REMEDATION SYSTEM EVALUATION

**MATTIACE PETROCHEMICAL SUPERFUND SITE
GLEN COVE, NEW YORK**

Report of the Remediation System Evaluation,
Site Visit Conducted at the Mattiace Petrochemical Superfund Site
March 29-30, 2001

Final Report Submitted to Region 2
July 27, 2001

FIGURE 1-1. SITE LAYOUT SHOWING SELECT MONITORING POINTS AND THE WELLS ASSOCIATED WITH THE VAPOR EXTRACTION, GROUNDWATER EXTRACTION, AND WATER REINJECTION SYSTEMS. WELLS WITH SIGNIFICANT CONTAMINANT CONCENTRATIONS ARE INDICATED

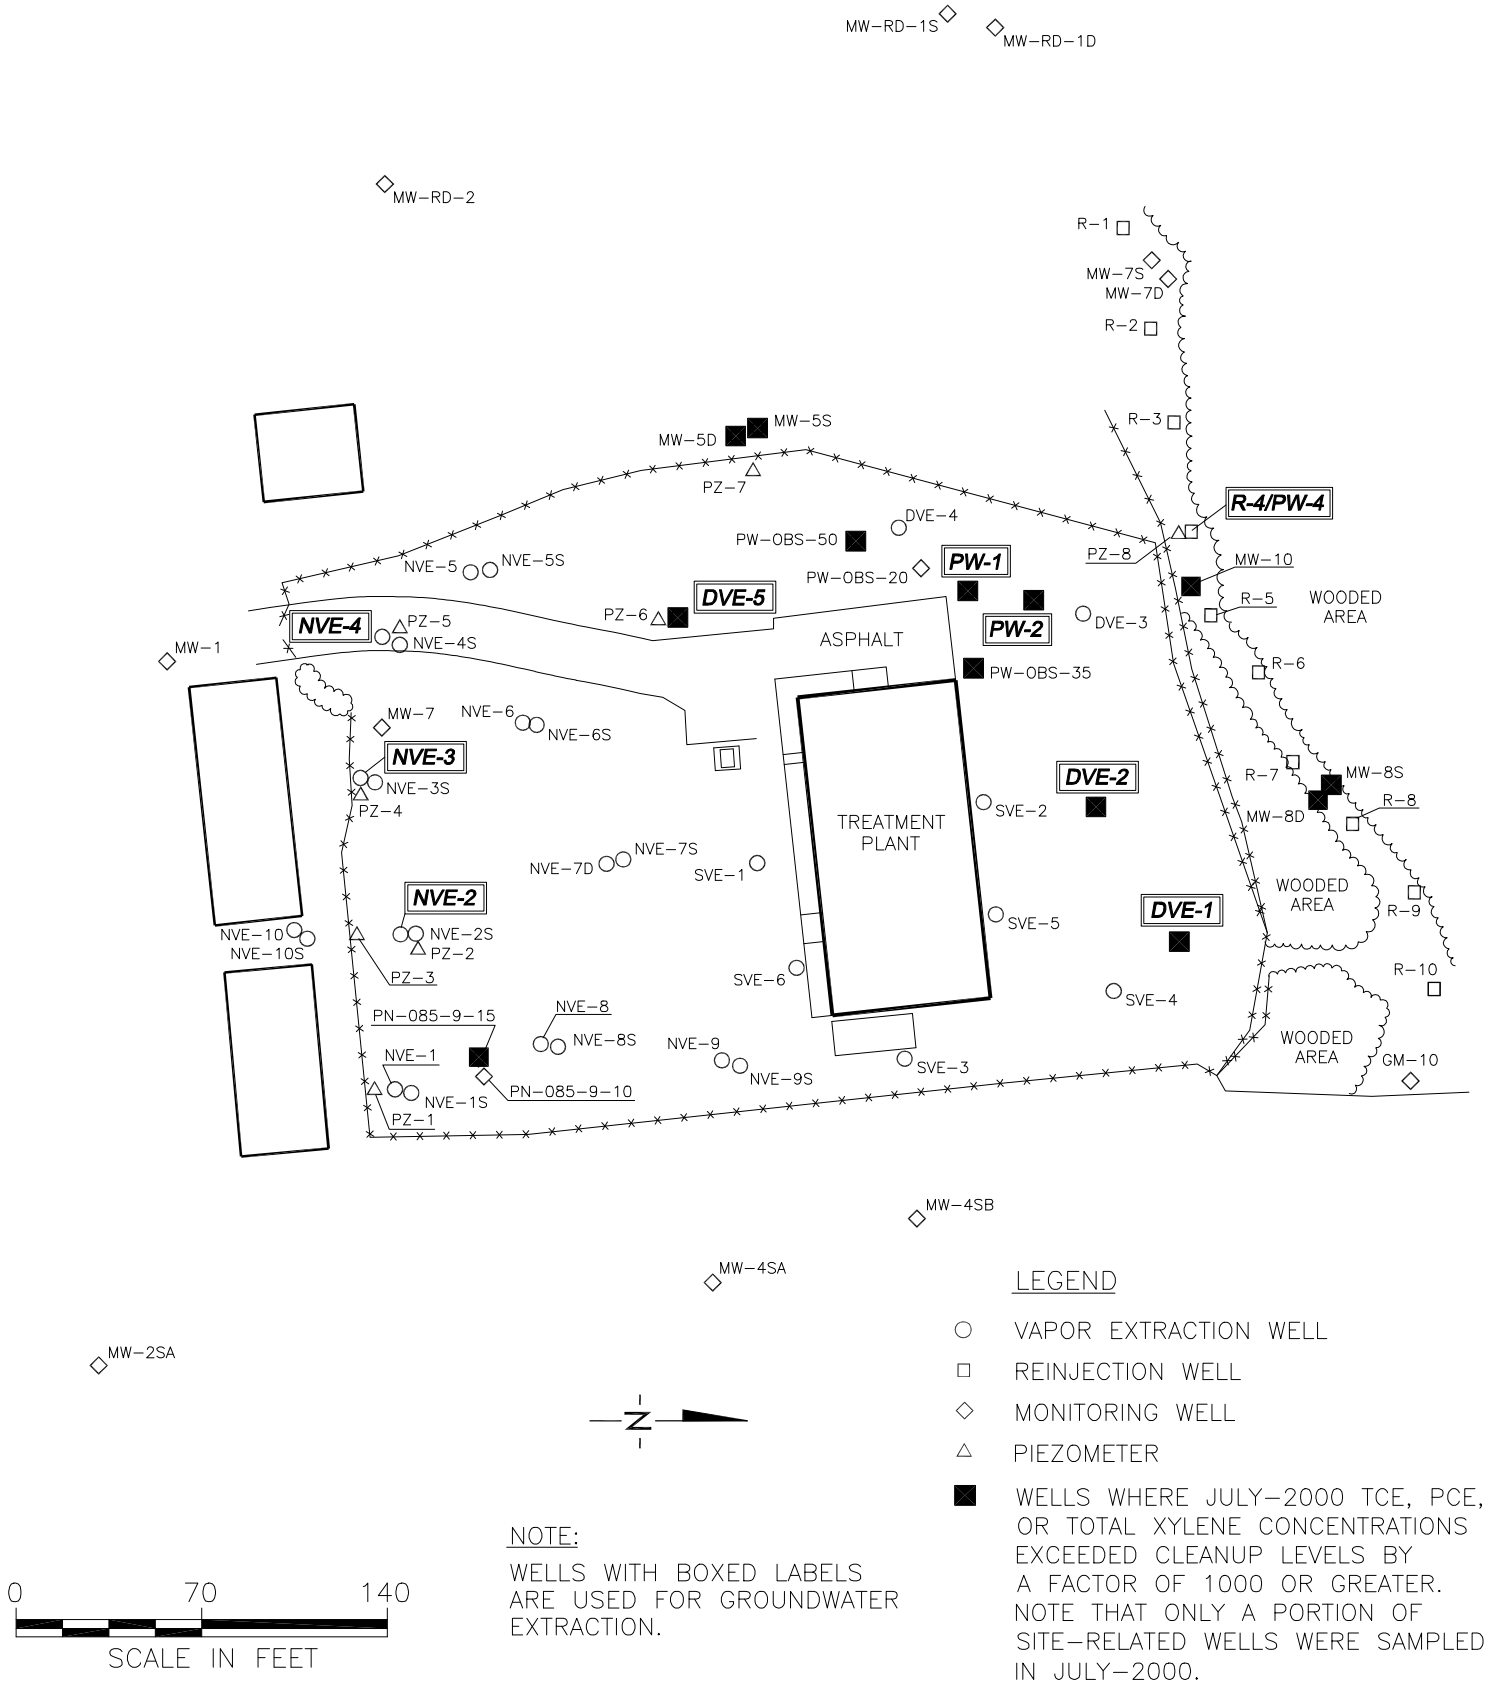
Despite extraction from PW-1, PW-2, and PW-4 capture in the northwestern corner of the site is questionable. Furthermore, capture is compromised by the injection of water through reinjection wells R-5 through R-10. Approximately twice the amount of water that is extracted and treated is reinjected through these wells (the city water used for quenching is also reinjected). Although the contractors have analyze potentiometric surfaces on a semiannual basis to determine capture, these surfaces were generated using water level data from the groundwater extraction wells, and capture was likely overestimated.

Capture in the southern half of the site is also likely limited due to the tight formation and the low pumping rates. NVE wells 2, 3, and 4 are each extracting approximately 0.1 gpm from the relatively shallow and tight formation. Although new piezometers (PZ-2 through PZ-4) are adjacent to these wells and may show capture a few feet from these wells the wells are located in a straight line along the southern boundary in 50-foot intervals. Therefore, capture along this southern boundary is likely incomplete. No groundwater extraction is occurring in the southeastern corner.

approximately 100 feet to the north of R-5 through R-10. To provide information about the potentiometric surface in this area, two piezometers should be installed that screen the contaminated formation, one of them approximately 50 feet north of MW-8s and other approximately 50 feet north of MW-10. The optimal depths of these piezometers should be determined based on the geoprobe results. It should be noted that access to this area may be limited as it is heavily wooded and may be part of the nature preserve. For approximately \$5,000 a small geoprobe can be hired for two to three days and provide 12 to 15 samples. The two piezometers can be installed for approximately \$2,000 a piece.

- To the west of the site, one piezometer could be added approximately 20 feet to the north MW-5s. This new piezometer, in addition to MW-5s and PZ-7, would provide a cluster of three monitoring points in the same formation for determining the local horizontal hydraulic gradient. Hydraulic gradients from water-level measurements of PW-OBS-50 and PW-OBS-20 should also be analyzed. These gradient should indicate flow toward DVE-5 or PW-1 and PW-2 if capture is adequate, and an additional groundwater extraction well may be necessary in this area if capture is not adequate. The recommended piezometer would cost approximately \$2,000.

- To the south of the site, two monitoring wells could be added to verify capture from NVE-2, NVE-3. These two monitoring wells should be located along the southern boundary of the site or preferably 10 feet further south (if permission is granted) and 30 feet on either side of NVE-2. These two new wells should be sampled semi-annually for VOCs, and the semi-annual sampling of MW-1 and MW-7 should continue. If concentrations in these wells increase over time, it is likely that adequate capture is not provided. In this case, additional wells, or perhaps a collection trench and sump should be installed to provide additional capture. Installation for each of the two new monitoring wells should cost \$10,000. The analytical work for semi-annual sampling of the two new wells should cost approximately \$1,000 per year.

- Even with the addition of these piezometers, a significant gap exists between groundwater extraction through NVE-4 and DVE-5. Piezometers or monitoring wells may be required to verify capture of contaminants between these two wells.
